UCB Project Manager	David Byrne
Campus Standards Section #	B1011 – Structural Analysis and Design: Embedded Conduit
Type of Issue	Embedded Conduit in Level 1 concrete slabs
CU Standards Language	<i>Embedded Conduit:</i> <i>a. UCB cautions against embedding conduit within horizontal structural elements, even if such conduit is incorporated into the structural analysis. UCB experience indicates significant practical problems with overlapping conduit and large concentrations of conduit which cannot be accurately accounted for in the design phase.</i>
Variance Request	Conduits in level 1 structural slab

Type of Issue Embedded Conduit in concrete topping slabs above mass timber

Type of Issue Conductor Material

University of Colorado
Boulder
CHEMISTRY AND
APPLIED MATHEMATICS

SHEET NO.
EFD-0.31

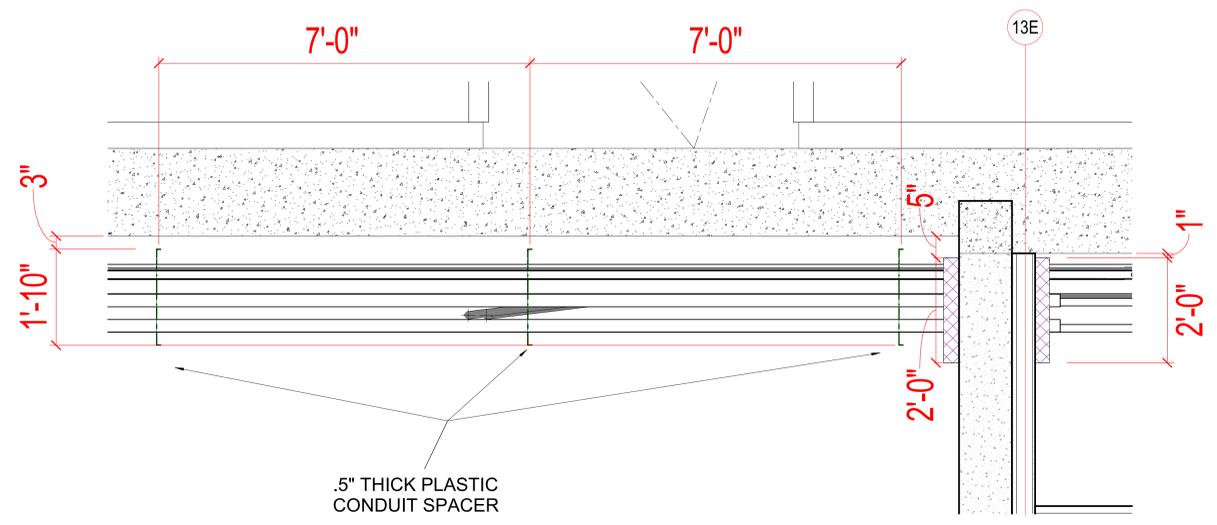
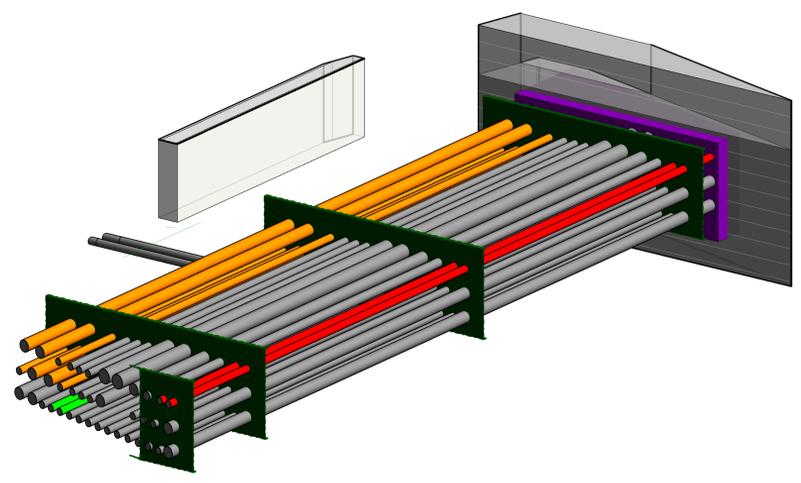
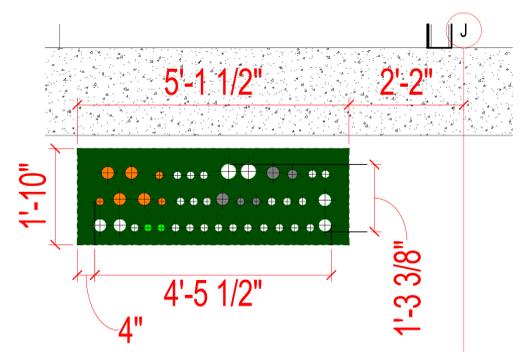
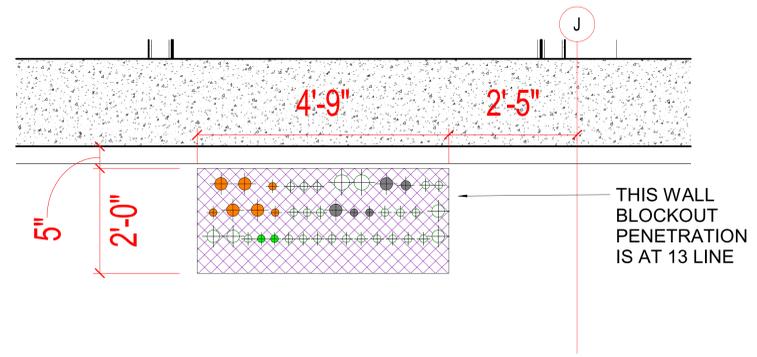
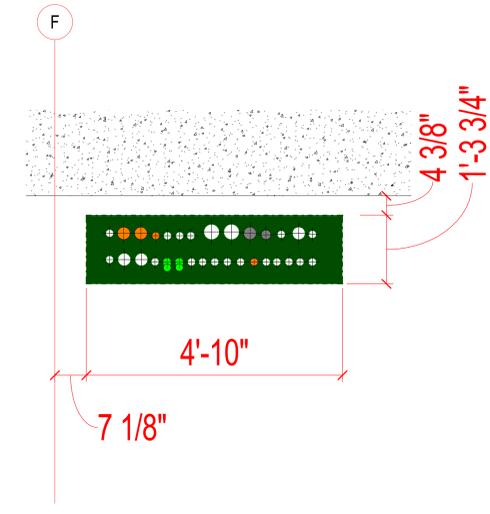
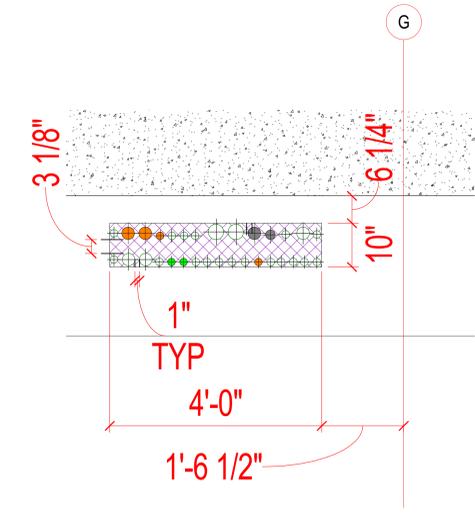
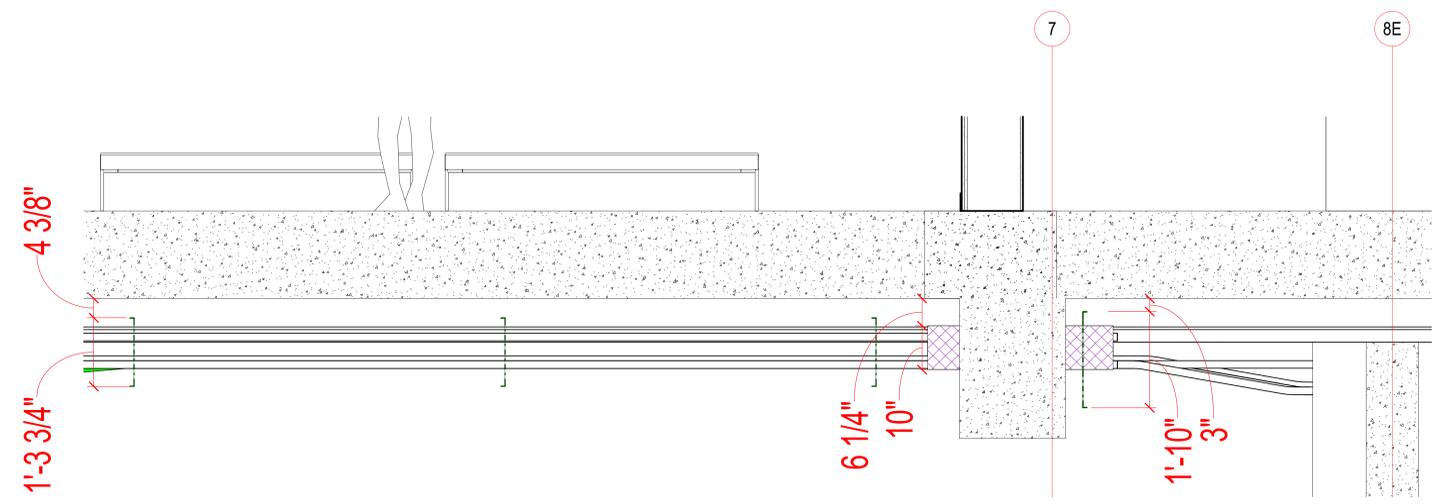
Scenario 1: Level 1 slab-on-void feeder duct bank

- a. The project site has expansive soils requiring a slab on void. The hydrostatic uplift pressures do not allow conduits to be direct buried or concrete encased below the slab in the void space without special provisions and numerous vapor barrier penetrations. The design and construction team proposes installing the conduits in a duct bank poured with the level 1 slab. Attached is the conduit routing plan that has been reviewed by the design and construction teams as well as details showing the construction of the duct bank. Routing overhead was investigated. However, the following roadblocks were identified:

- b. The conduit routed below the level 1 slab will be difficult to alter in the future. It will also

be difficult to route additional feeders from the basement to other areas of the building in the future based on the amount of MEP equipment in the basement corridors, regardless of routing overhead or below the level 1 slab. The team proposes installing additional spare conduits for future changes to the south end of the building routed via the duct bank. We are including (2) 2" conduits from the main electrical room to the level 1 south electrical room via the duct bank with (1) 2" conduit stubbed between each floor.

EFD-0.03

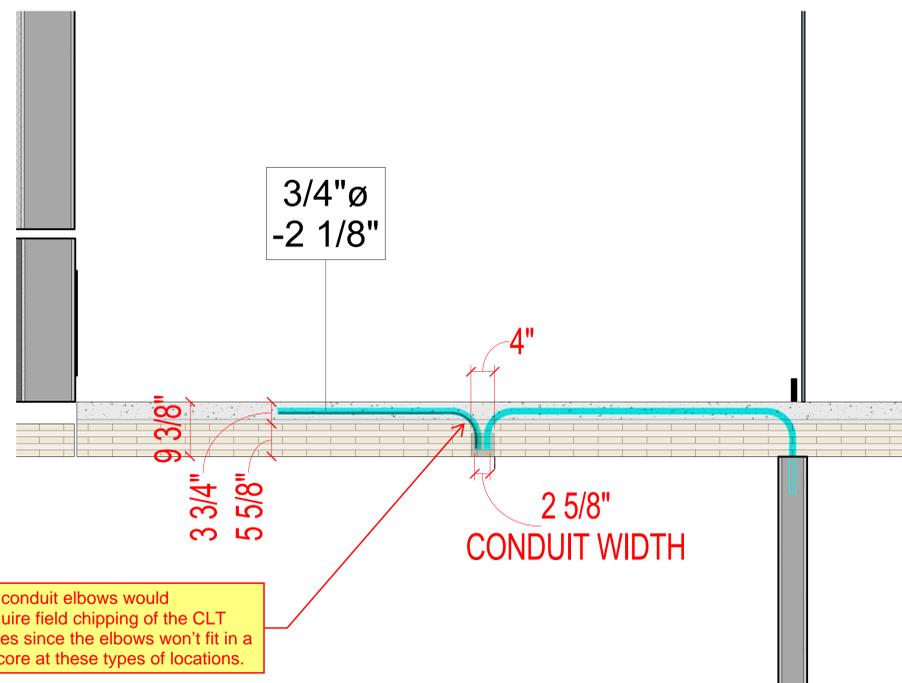
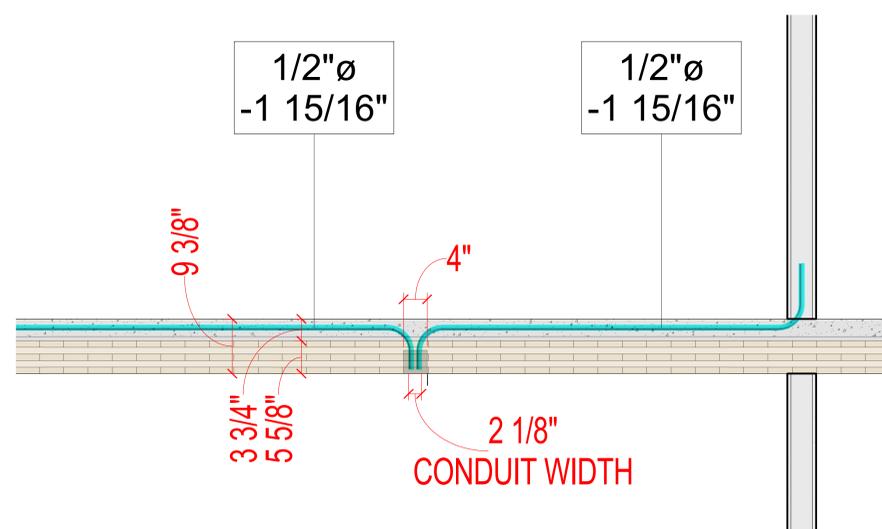
Variance Request Description: To significantly reduce the amount of exposed conduit in the mass timber areas on the CHAP building, the design and construction teams would like to route smaller conduits within the 3” topping slabs of.

These conduit pathways would serve floor boxes, fire alarm devices, light fixtures, lighting control devices, and other ceiling mounted devices. The conduits will be coordinated such that they do not cross each other and stay in the middle 1/3 of the topping slab per structural requirements.

Shallow floor boxes are proposed where required so that they are flush with the 3” topping slab in lieu of poke throughs which would be visible on the level below. Attached are details of how the conduit would be routed within the topping slab and through pre-cored openings in the cross-laminated timber floor. ½” conduit is proposed for all ceiling mounted devices due to the constructability of the bend radius. ¾” conduit elbows cannot be installed from the topping slab into a 4” core due to their size relative to the depth of the topping slab. ¾” conduit elbows would also require field chipping of the CLT cores since the elbows won’t fit in a 4” core. Per CU standard, all other areas of the project would use ¾” conduit.

Sheet Number
E0.10

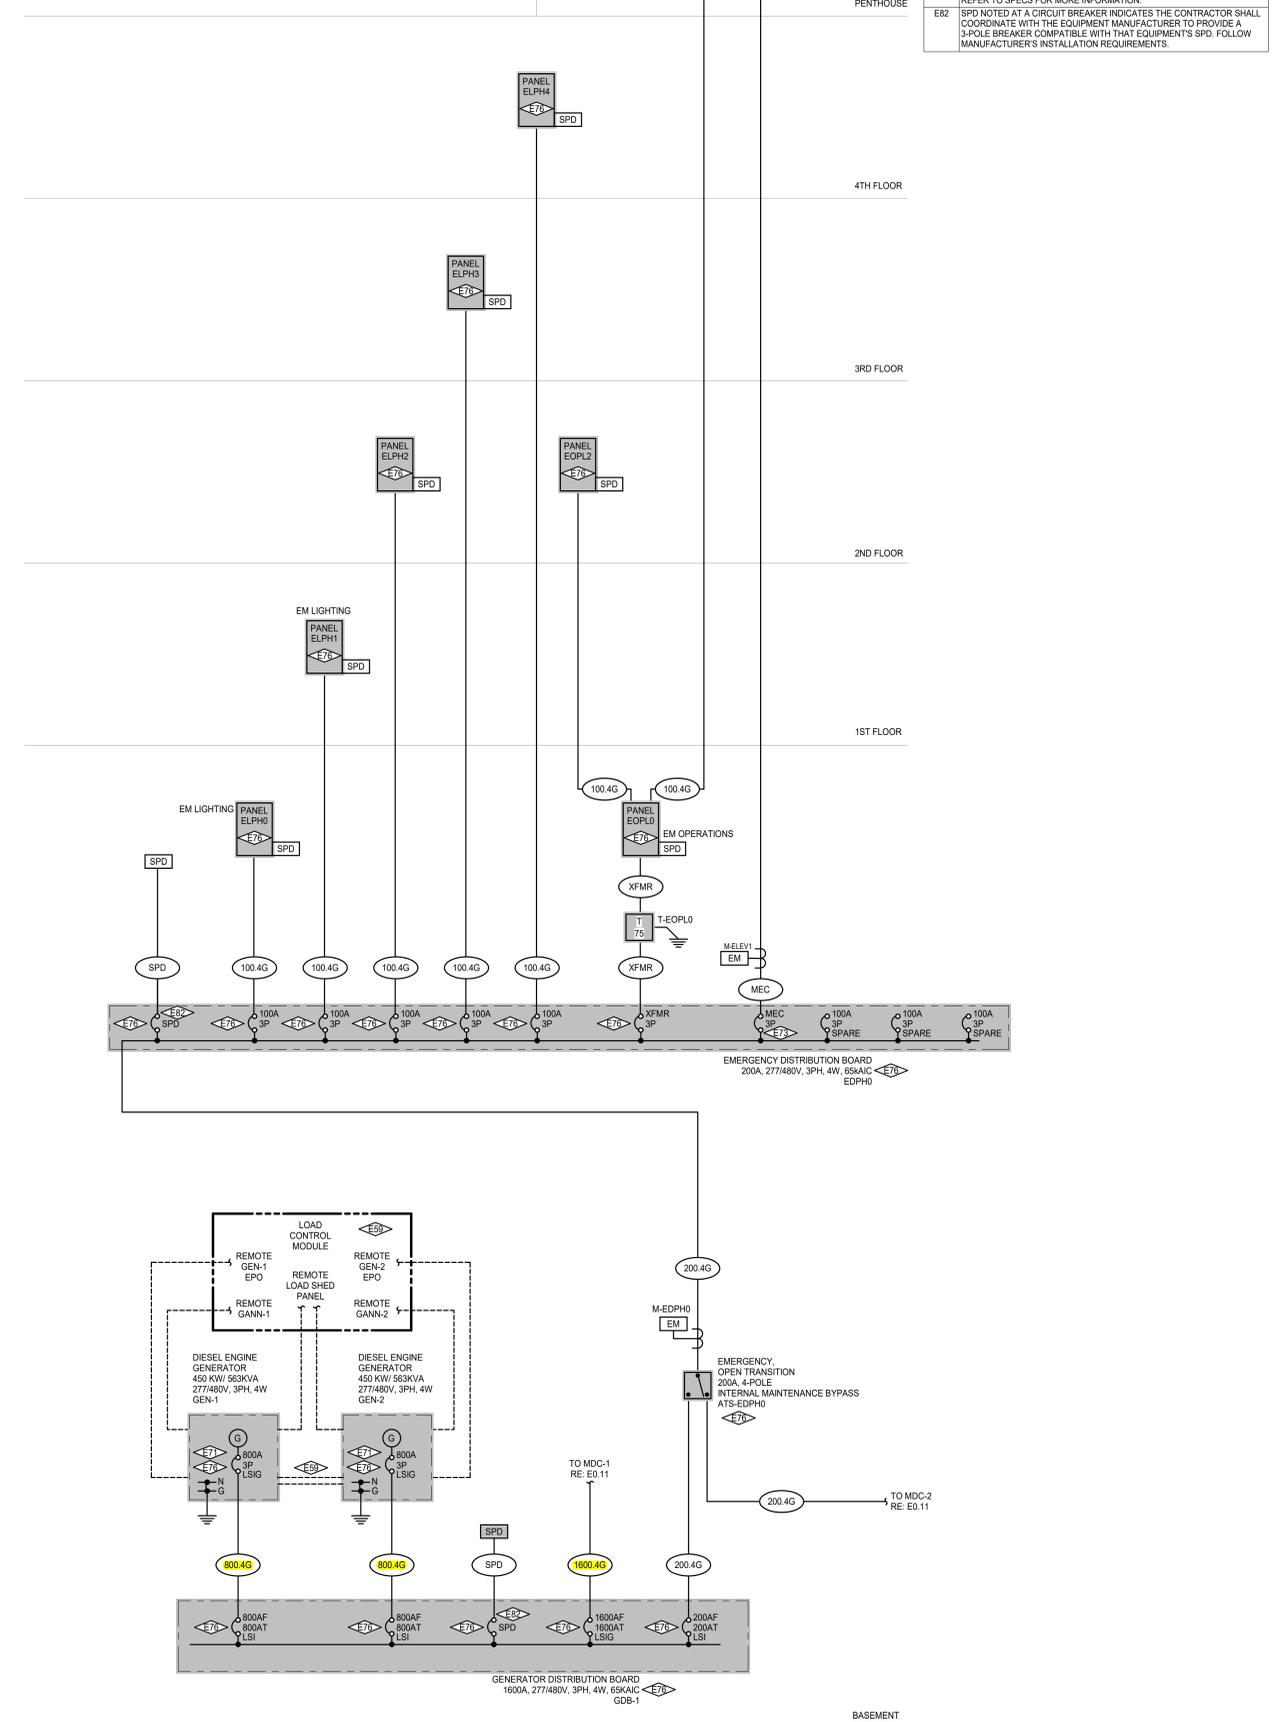
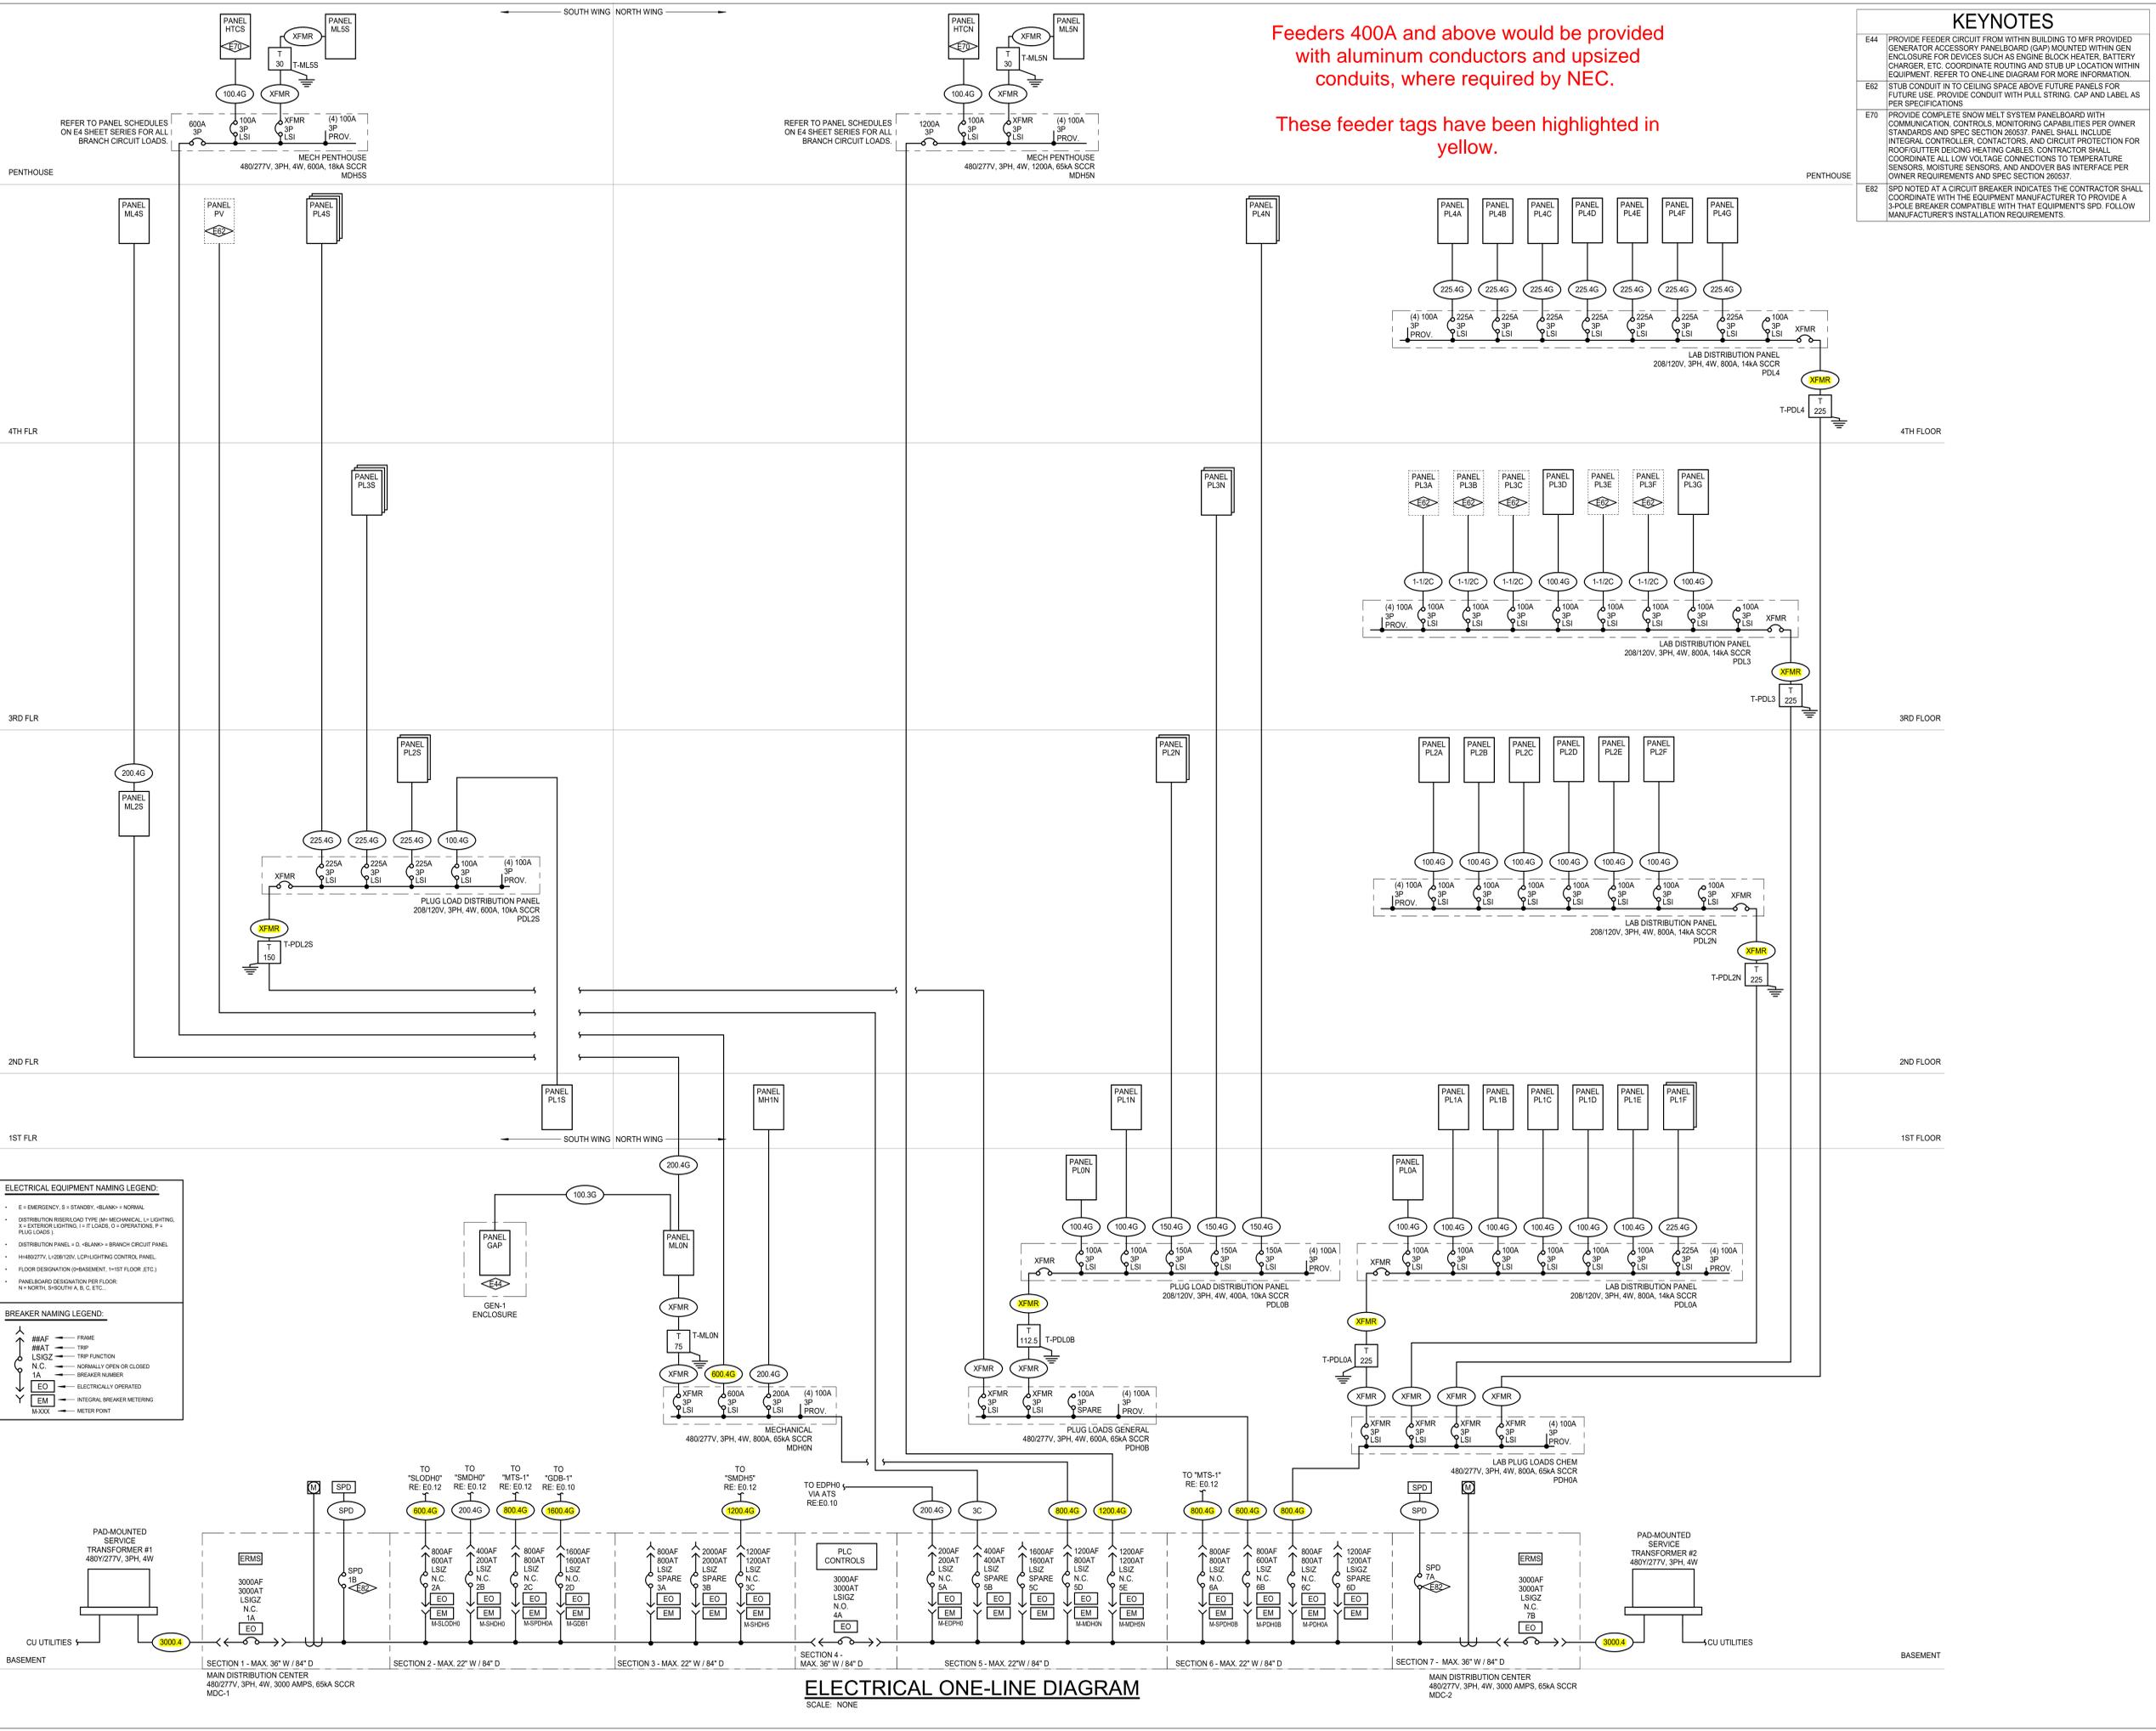
Variance Request Description: There is a large cost benefit to utilizing aluminum conductors in lieu of copper conductors in certain applications on the CU CHAP project. Modern aluminum conductors are reliably used in various types of critical facilities, including hospitals, data centers, and labs. Added maintenance costs are not considered a concern with this variance and end user experience will be the same regardless of conductor material. We suggest allowing their use for feeders over 400A which results in a savings of \$200,000. This savings accounts for increased wire and conduit sizes for the change of material. Attached are the one-line sheets to indicate which feeders will be aluminum.

Feeders 400A and above would be provided with aluminum conductors and upsized conduits, where required by NEC.
These feeder tags have been highlighted in yellow.
